Moldova Roads Rehabilitation V
NATIONAL ROAD ADMINISTRATION

CLARIFICATION DOCUMENT No.1

Rehabilitation of M1 – Leușeni - Chișinau Road:

(client's reference RSP/W16/01-02)

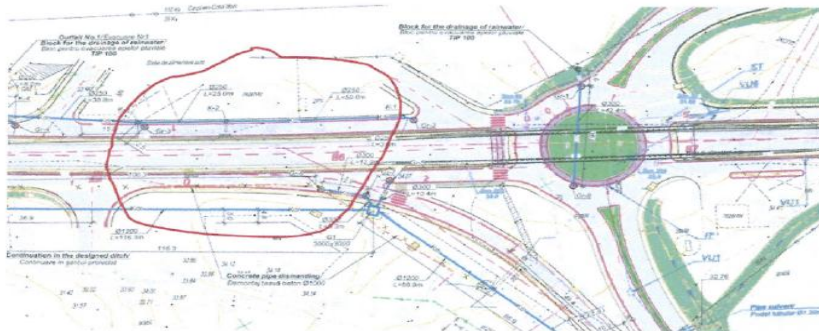
differ from the drawing in "Vol 2_Book 3_Culverts" on page 36.

Bus stops are not shown.
